# UNITED STATES PATENT AND TRADEMARK OFFICE

APPLICATION NO.	FILING DATE	FIRST NAMED INVENTOR	ATTORNEY DOCKET NO.	CONFIRMATION NO.
10/531,882	05/17/2005	Matthew Guinness	UDL23.001APC	4536

<b>Office Action Summary</b>	<b>Application No.</b> 10/531,882	<b>Applicant(s)</b> GUINNESS, MATTHEW	
	<b>Examiner</b> Travis Chambers	<b>Art Unit</b> 2833

## DETAILED ACTION

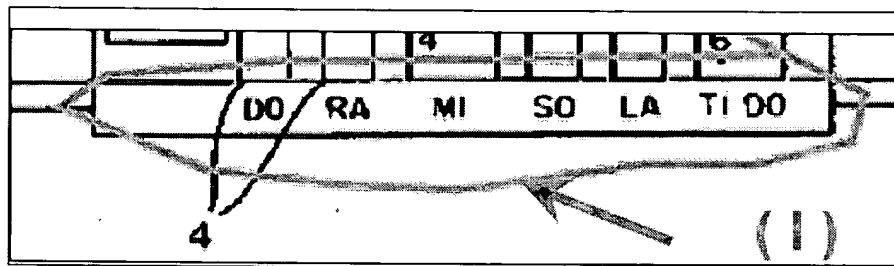
In reference to claim 1, Hesnan teaches a first element (2 ; figure 2) that comprises a first set of indicia (6,7,8 ; figure 2 ) representing in linear form the structures of a plurality of musical scales, chords and/or modes, and a second element (3 ; figure 2) that comprises a second set of indicia (I; image below ) representing the names of the notes of a chromatic scale (pertaining to 7 ; figure 2), the second element (3 ; figure

2 ) being constructed and arranged for movement relative to the first element (2 ; figure 2 ) in two orthogonal directions (A and B ; figure 1), so as to indicate the relationship between the notes of the chromatic scale (pertaining to 7 ; figure 2) and the structure of a selected one of the musical scales, chords and/or modes.

The claim language "orthogonal direction" is not clear as to what structure the two directions are orthogonal too. Hesnan shows directions (A and B : figure 1 ) that are orthogaonal to the viewing angle.

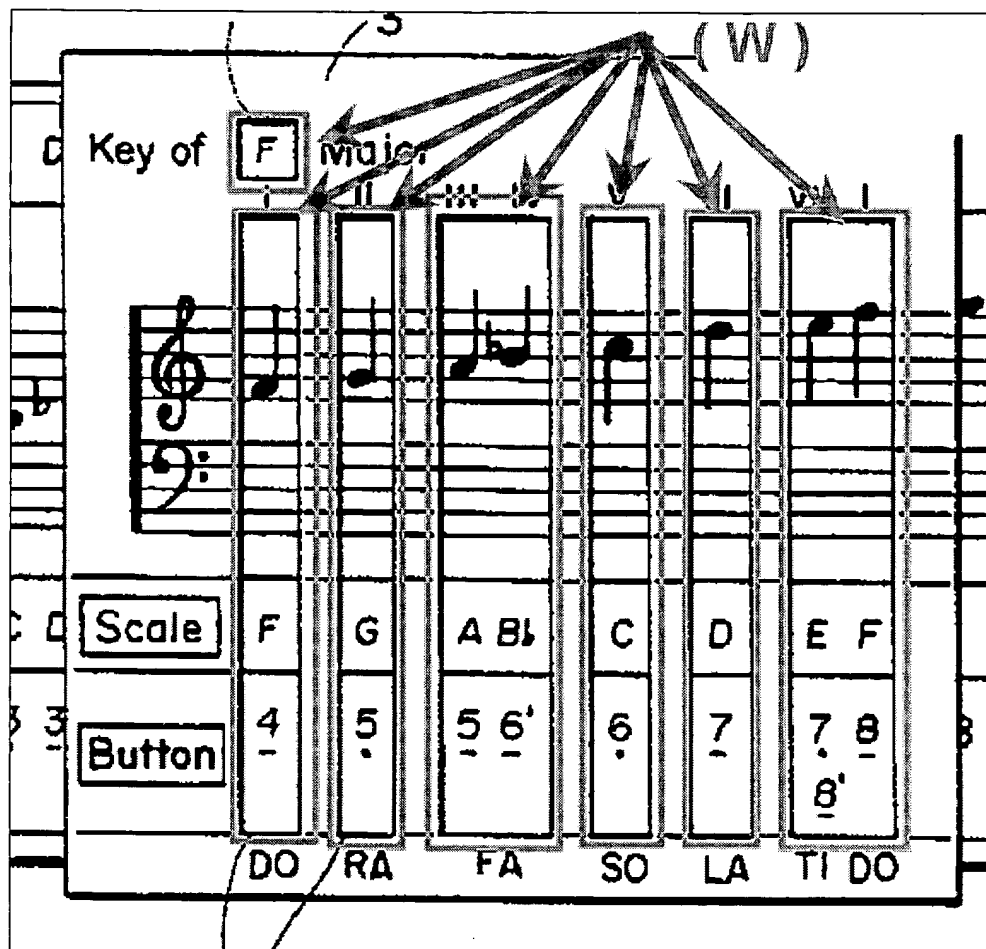
In reference to claim 3, Hesnan teaches wherein the first element ( 2 ; figure 2) is located within the second element ( 3 ; figure 2).

In reference to claim 4, Hesnan teaches wherein the second element ( 3 ; figure 2) comprises at least one window ( W; image below ) through which a portion of the first element (2 ; figure 2 ) may be viewed.

In reference to claim 5, Hesnan teaches the at least one window ( W ) comprises a slot ( 4 and 5 ; figure 2 ) or transparent portion that extends longitudinally and or radially (pertaining to Col. 4 lines 13-19, where 4 and 5 will extend radially due to cylindrical formation of 2 and 3).

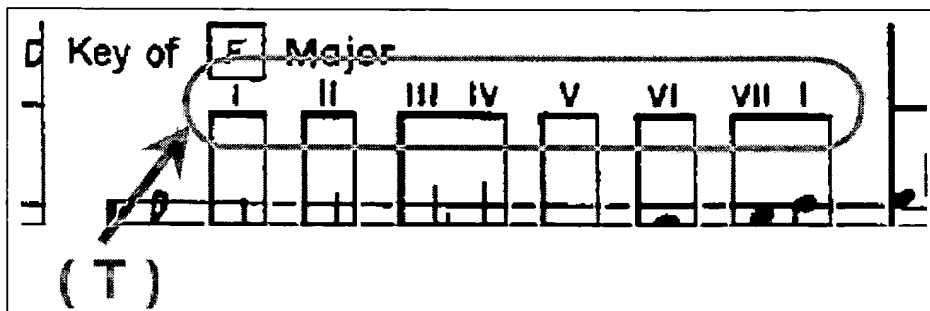
In reference to claim 7, Hesnan shows substantially the invention as claimed. While Calabro teaches the third element (14 ; figure 2) is constructed and

arranged for one axial movement ( second element held stationary and third element moves axially left and right) relative to the second element and only rotational movement relative to the first element (pertaining to 13 ; figure 2 of Calabro) .

In reference to claim 10, Hesnan teaches the second element ( 3 ; figure 2 ) comprises a third set ( T; image below) of indicia representing various key signatures and the third element (as discussed above in claim 6 – 14 ; figure 2 ) comprises a fourth set of indicia ( near lead line 17 ; figure 4 ) for indicating relative to the third set of indicia (T) the appropriate key signatures for a selected mote or key.
